Appendix A  
EPA Responses to Dispute Issues  
12/27/16

I. INTRODUCTION

## **II. LWG DISPUTE STATEMENT RESPONSE**

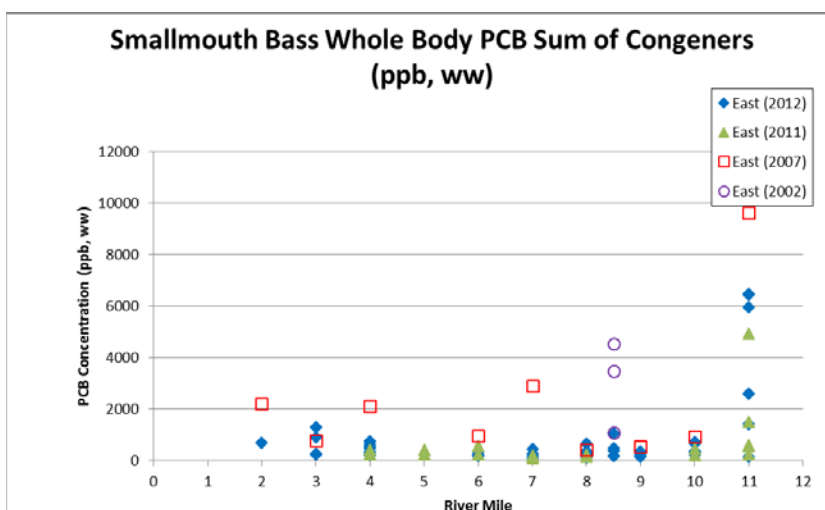
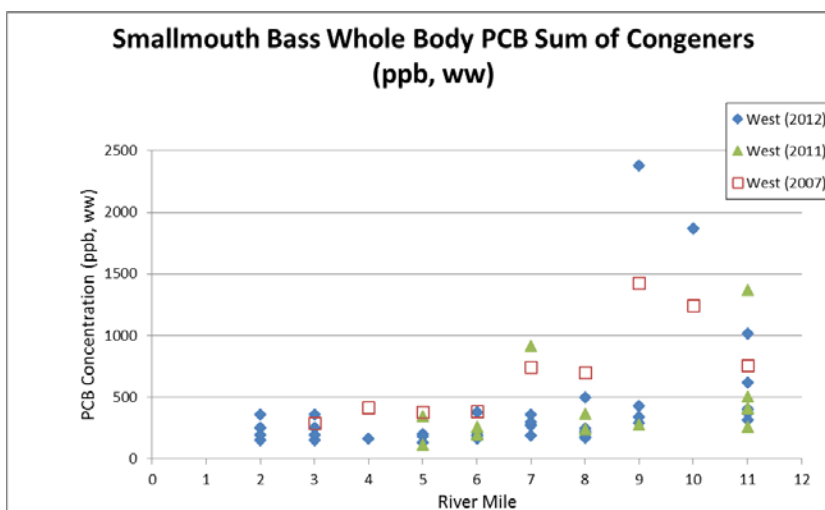
*It is unclear if the sitewide total PCB spatially weighted average concentration (SWAC) values presented in EPA's FS included the RM 11.2 information acquired during the Supplemental RI performed in Segment 1 (River miles 9 to 11.7). This creates a significant problem in the comparison of subsequent surface SWACs because it suggests site conditions at the time of the RI were actually cleaner than they were. This makes the demonstration of significant sitewide natural recovery more difficult and inaccurate.*

The 2016 FS clearly states in Section 1.3 that the data collected by the RM 11E Group were not included in the FS database. EPA reviewed the data prior to making the decision not to include in the database (although it is in the administrative record because EPA considered it) and determined that it would not significantly change the remedial footprints. EPA is unclear why the Respondent believes that the omission of this data would result in a significantly different SWAC since the data were collected to supplement the RI/FS data, not to recharacterize this area of the Site. EPA did not look at natural recovery Site-wide as the river dynamics are not consistent throughout the Site. EPA looked at natural recovery on a smaller spatial scale as discussed in Appendix D8 of the 2016 FS.
